GUILDERLAND PLANNING BOARD
PLANNING BOARD
P A C K E T
AUGUST 10, 2022
07:00 PM

3. CONTINUED PUBLIC HEARING. Possible Consideration of Reaffirming the SEQR EIS Findings and Possible Consideration for Site Plan Amendment Approval for the Apex at Crossgates (f/k/a Rapp Road Apartments) for a Previously Approved 222 Unit Multiple-Residence Community - SW Corner Rapp Rd/Gipp Rd - UG Family, LLC

Attachment: [LaBella Response to GPI Review Comments 2022--08--08.pdf](#)

Attachment: [LaBella Response to Delaware Eng Comments - 2022--08--08.pdf](#)

SITE DETAILS

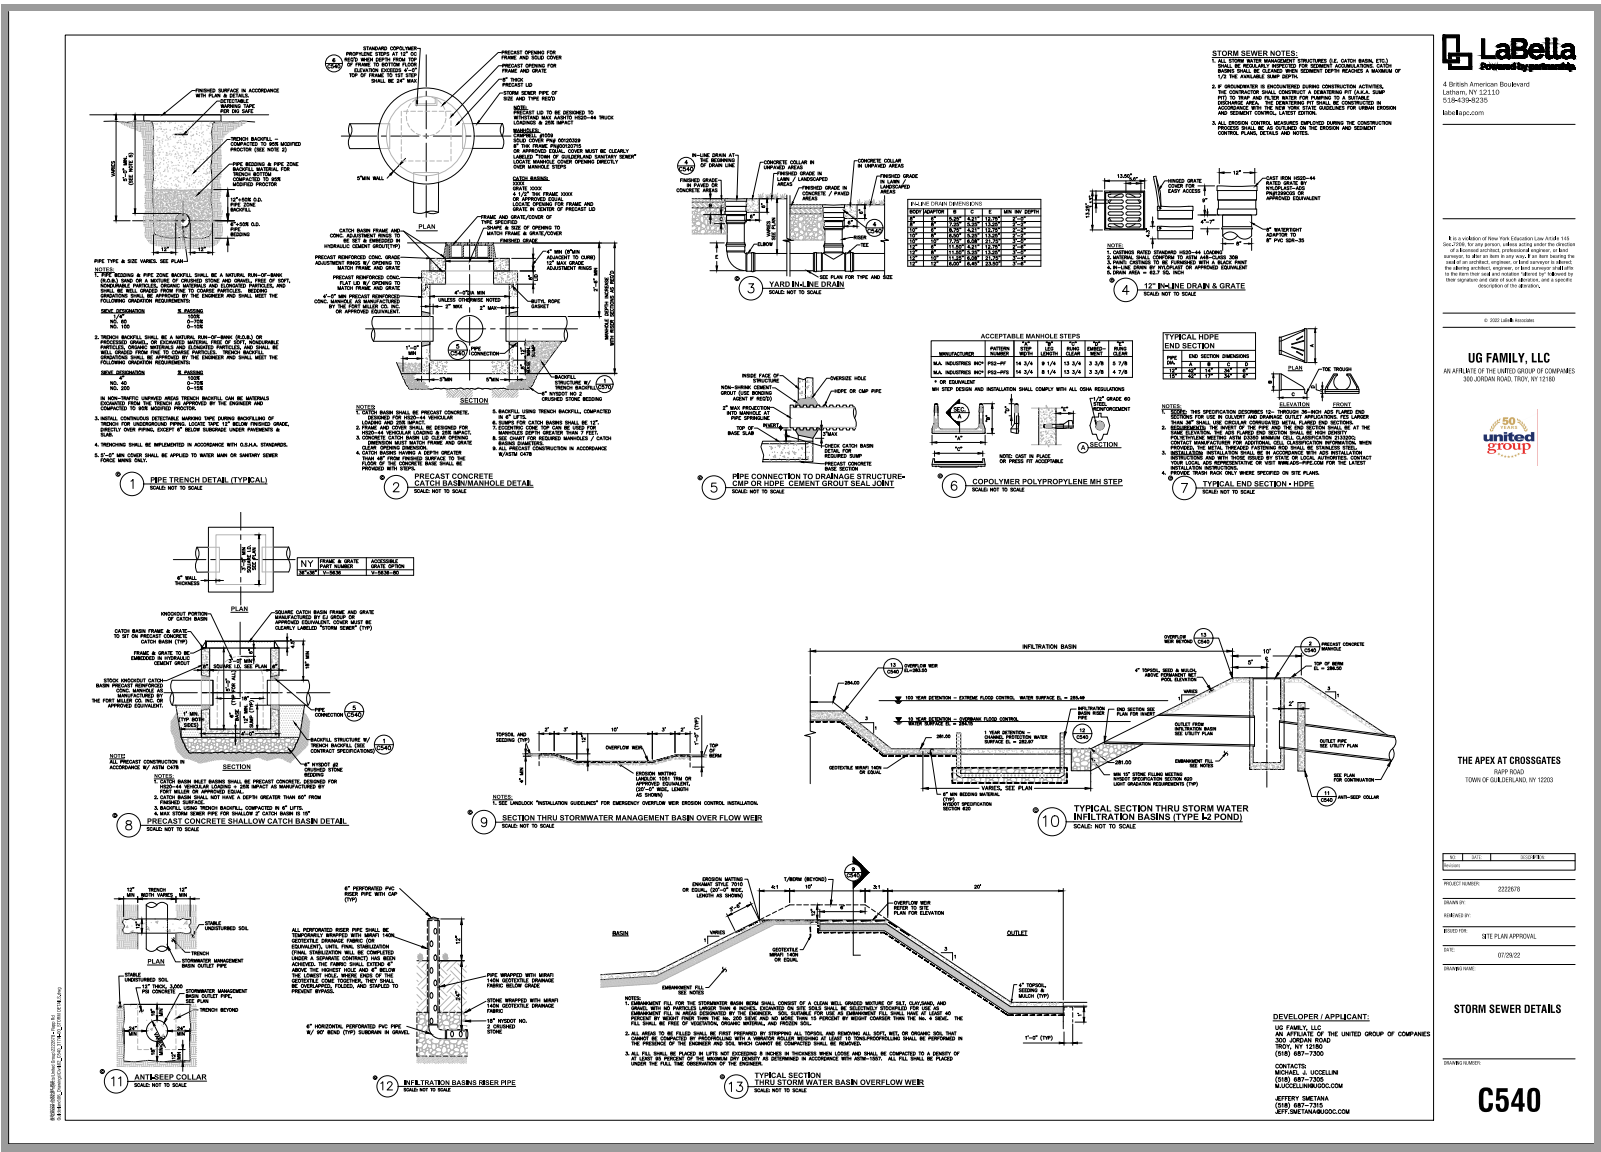
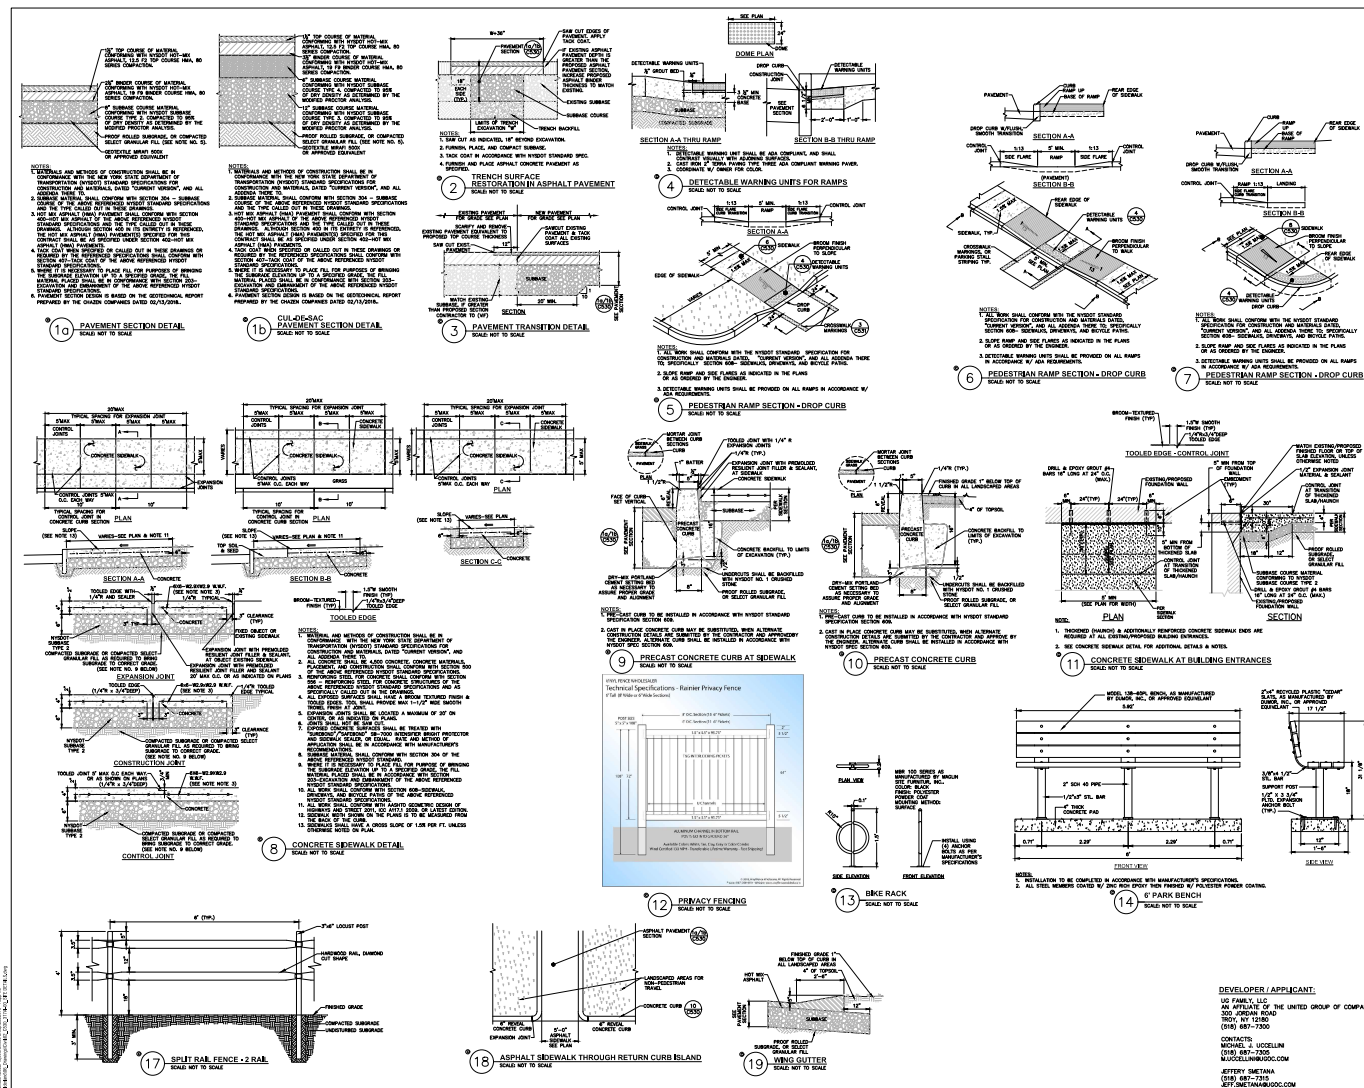
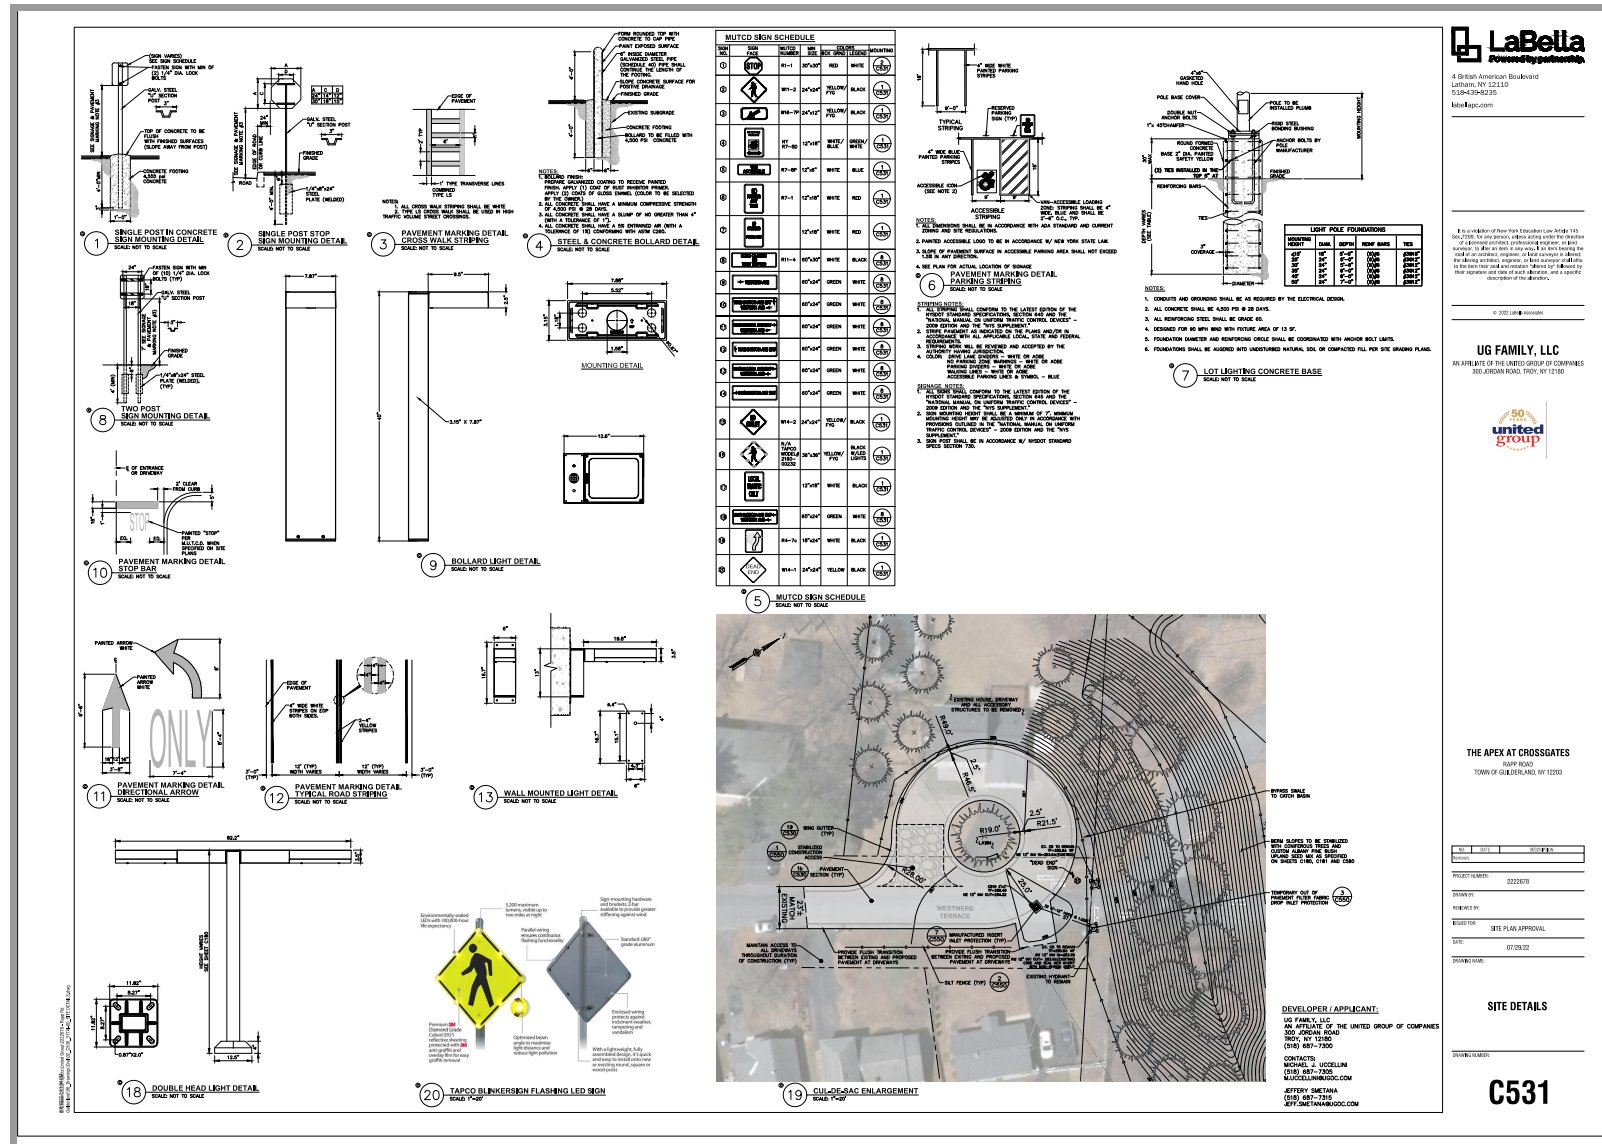
1. *A north arrow is needed on Detail 19 (the plan view of the cul-de-sac)*

2. *The provided pavement section does not match the Town of Guilderland standard road section detail. The following items were found to be inconsistent from the Town's standards:*

- a. *The pavement top course and binder course materials do not match the materials in the Town detail; however, they appear to be acceptable due to updated/current material standards from the NYSDOT.*
- b. *Town standard required 5" minimum of asphalt while only 4" total is proposed.*
- c. *The proposed subbase section does not meet Town standards for materials and depth. LaBella is proposing 8" of Type 2 subbase when the Town standard calls for 6" of Type 4 with 12" of Type 3 subbase material below that.*

12. *A detail should be provided for the wing edge curb construction as there does not appear to be one included on the plans.*

Response: A north arrow has been added to the detail on sheet C531.

Response: Detail 1b on sheet C530 has been added to provide a separate pavement section for the cul-de-sac meeting the Town of Guilderland requirements.

Response: Detail 19 on sheet C530 has been added for the proposed wing gutter.
